# PARTS & SERVICE NEWS

REF NO. AA01056B

- SUBJECT:** MOUNTING HARDWARE CHANGE FOR HOOD PANEL, LOW SIDE DOORS AND RADIATOR GUARD
- PURPOSE:** To provide better stability to sheet metal that has cracked due to inadequate clamping loads (hood panels and low side doors) and inadequate tension ratios (radiator guard).
- APPLICATION:** Komatsu Wheel Loaders  
WA800-3LC: A50001 and UP  
WA900-3LC: A50001 and UP
- FAILURE CODE:** 5400HA
- DESCRIPTION:** Mounting hardware change for hood panel, low side doors and radiator guard.

FIGURE 1. VANDALISM PROTECTION

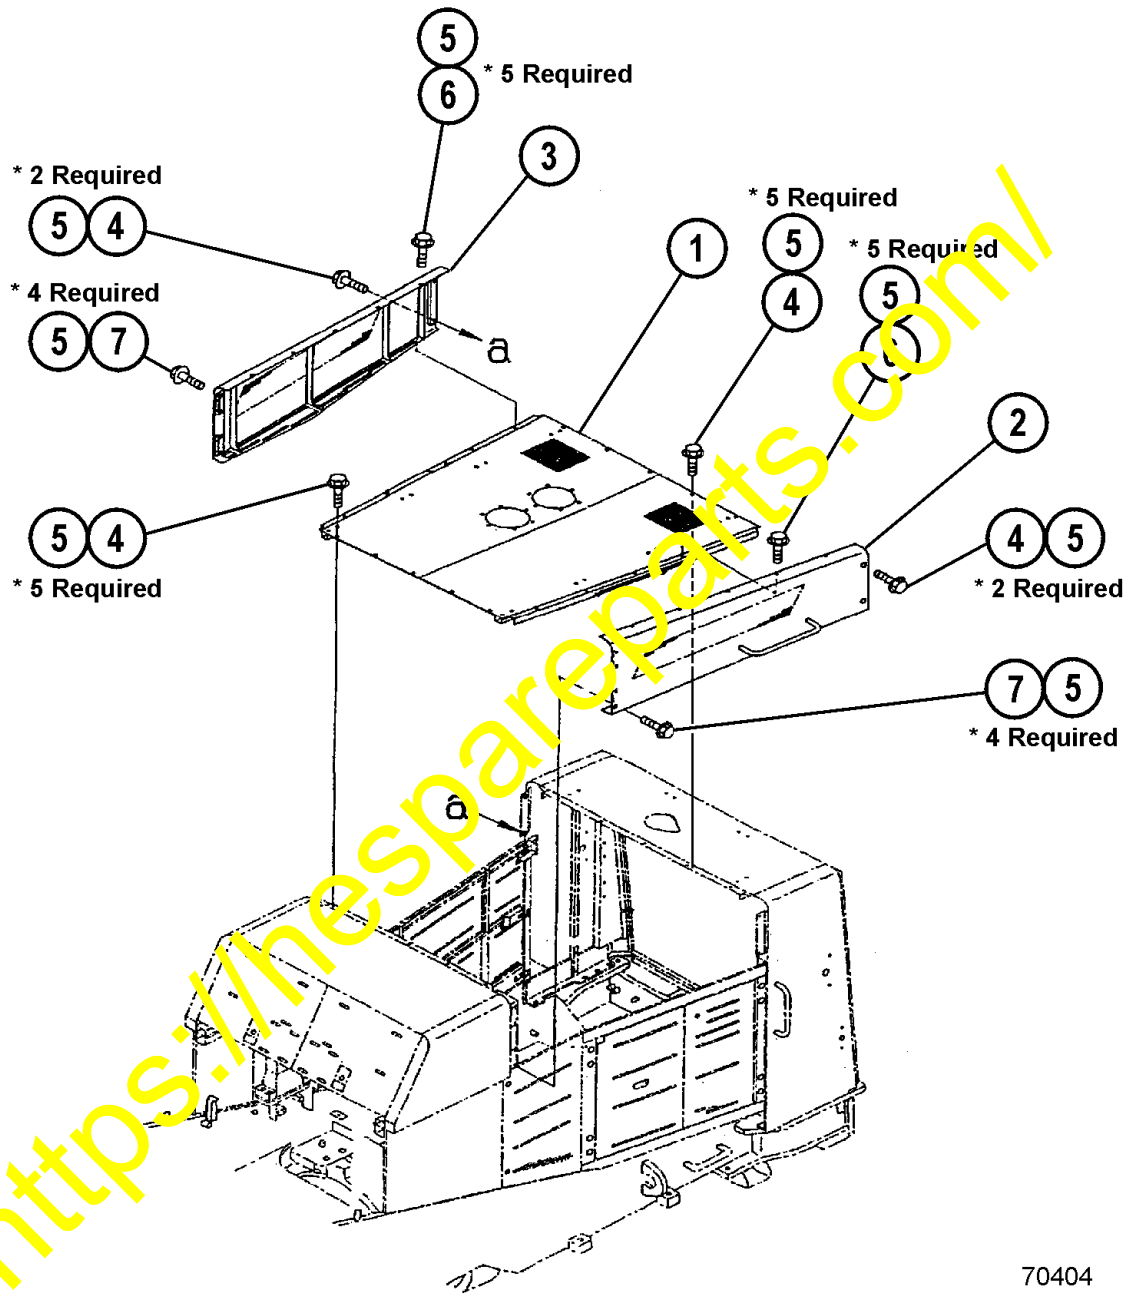
During machine operation, the clamp load of the current washer head bolts does not provide the adequate clamp force needed to give stability to the panels. The inadequate clamp force allows vibrations to loosen the bolts and crack the panels at the mounting areas. In order to provide adequate clamp force, washer head bolts (01435-010XX and 01435-012XX) need to be replaced with the new hardware listed in Table 1. Refer to Figures 1-6 for locations of washer head bolts that are to be replaced.

- 1. Lock
- 2. Cover
- 3. Bolt (01010-81225)
- 4. Washer (01643-31232)
